To: T10 Technical Committee
 From: Rob Elliott, HP (elliott@hp.com)
 Date: 29 June 2007
 Subject: 07-300r0 SAS-2 Configurable expander table-to-table error handling

Figure 48 — Externally configurable expander device and table-to-table attachment [\[no change\]](#)

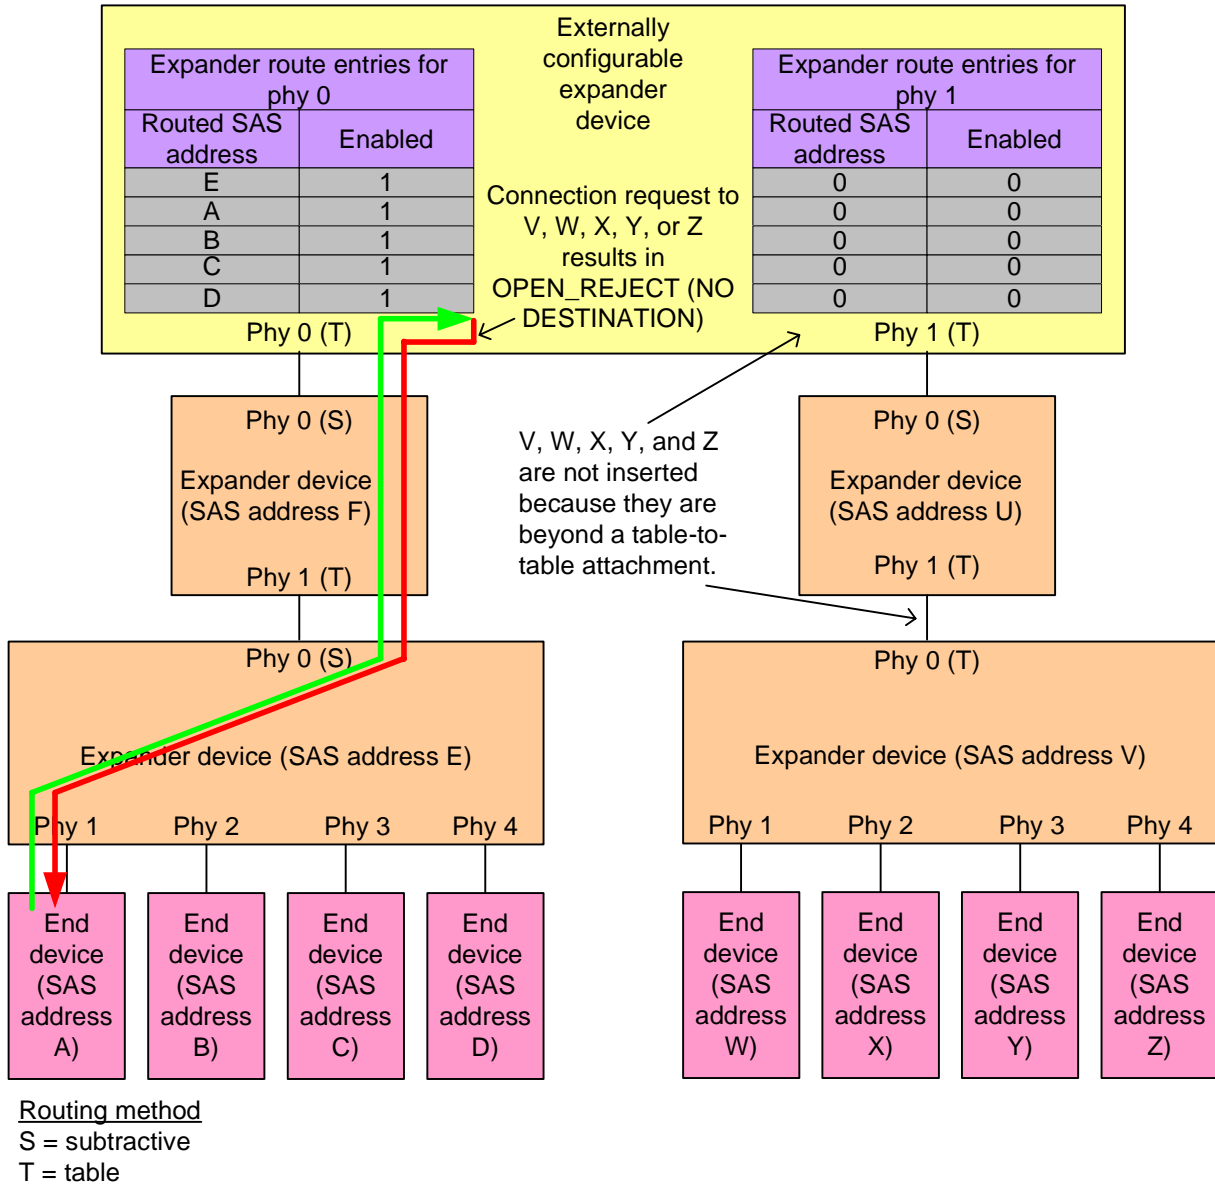
SAS addresses of devices attached beyond expander phys that are attached table-to-table shall not be included in the expander route table. This includes the SAS address of the first expander device that is attached table-to-table and the SAS address of every device attached beyond that expander device.

NOTE 1 - Not including those SAS addresses provides compatibility with management application clients compliant with previous versions of this standard. End devices in SAS domains containing externally configurable expander devices and table-to-table attachments may not be able to establish connections to each other. End devices in SAS domains containing only self-configuring expander devices compliant with this standard (i.e., supporting table-to-table attachments) are able to establish connections to any other end device.

Figure 48 shows an example of a route table that does not include SAS addresses beyond a table-to-table attachment.

Figure 49 — Expander route index levels example

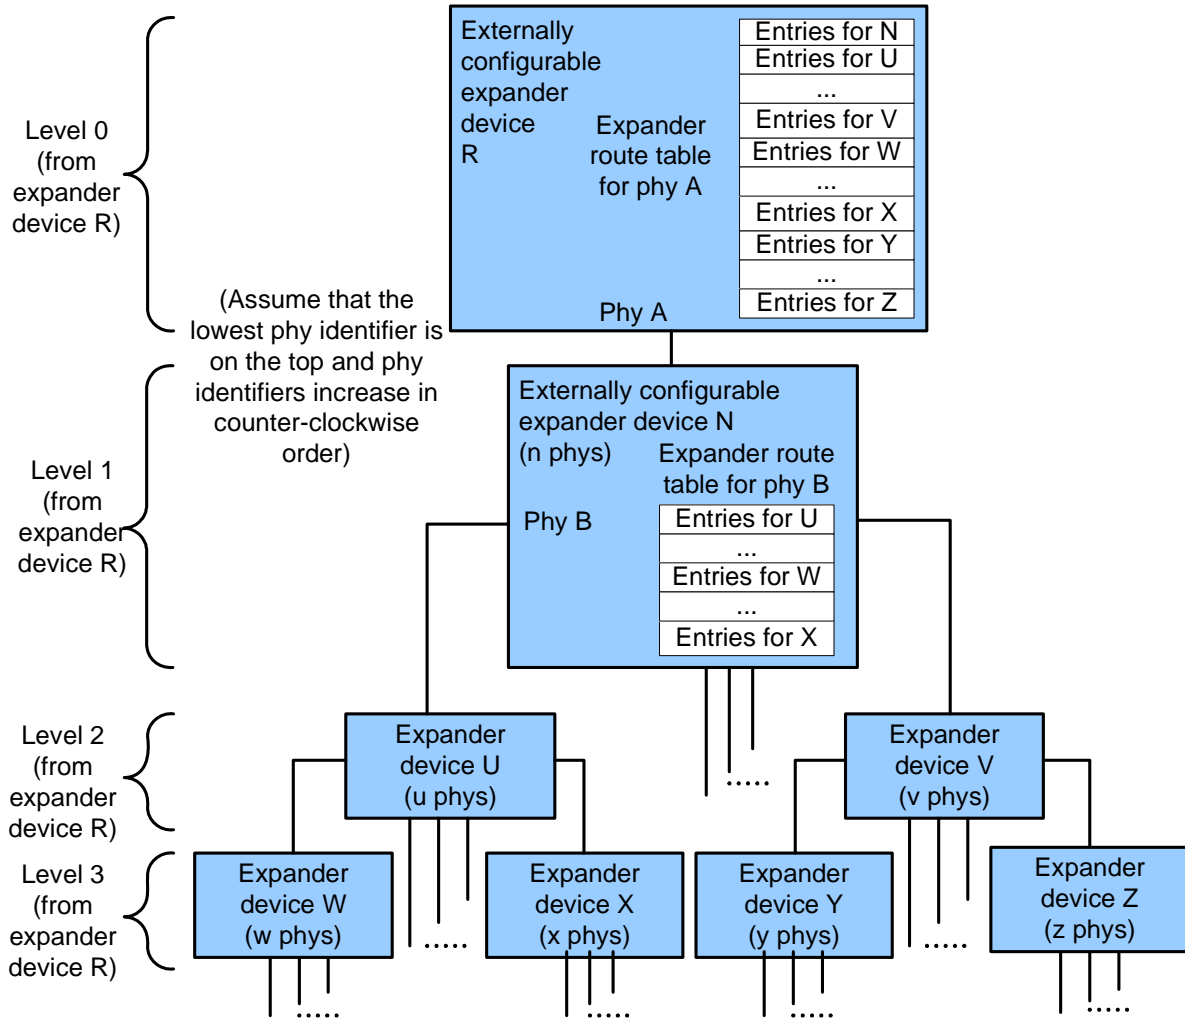
Table 1 shows how the expander route table is configured for externally configurable expander device R phy A in figure 49.

Table 2 shows how the expander route table is configured for externally configurable expander device N phy B in figure 49.

Figure 50 — Expander route index order example

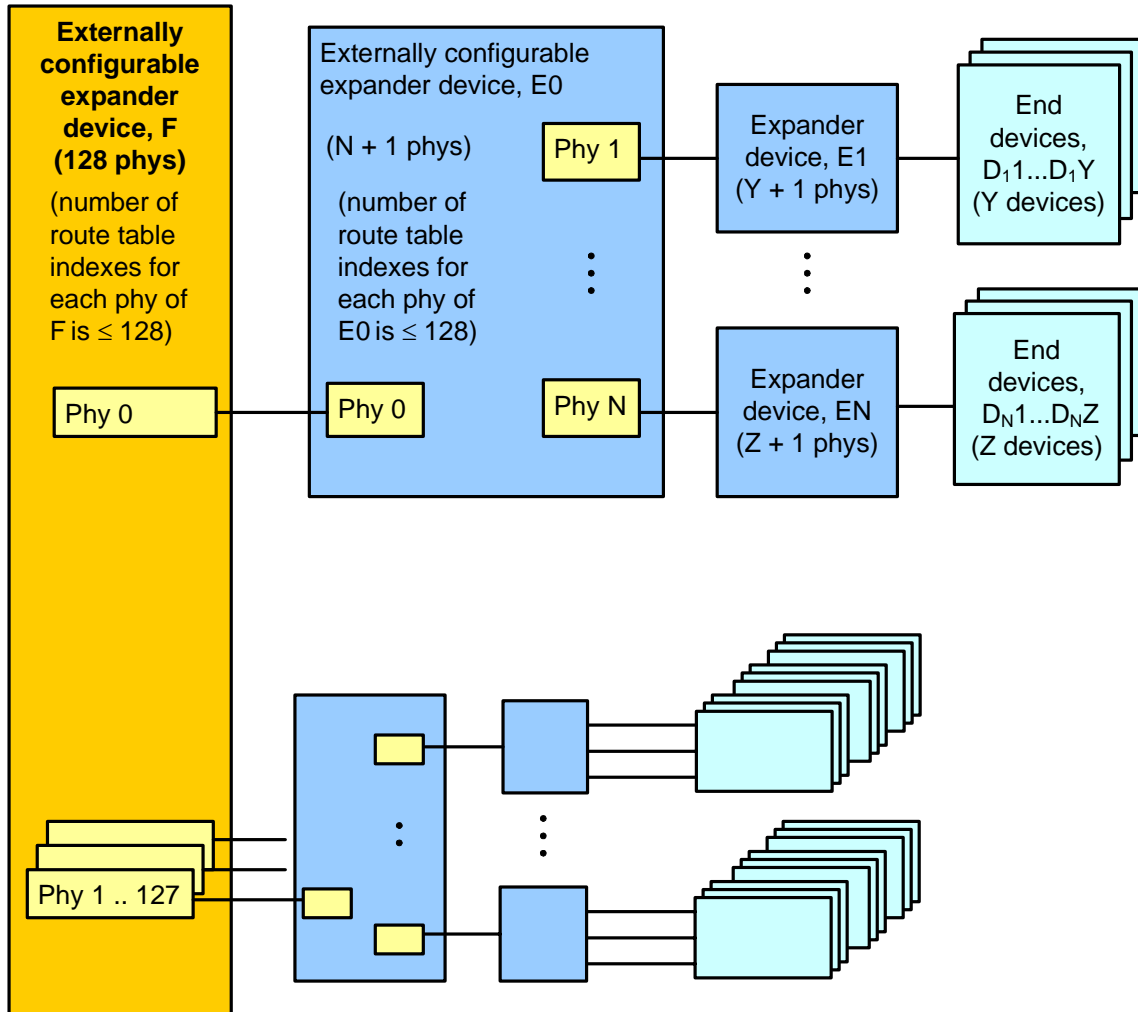
Table 3 shows the expander route index order for externally configurable expander device E0 phy 1 in figure 50.

Table 4 shows the expander route index order for externally configurable expander device F phy 0 in figure 50.
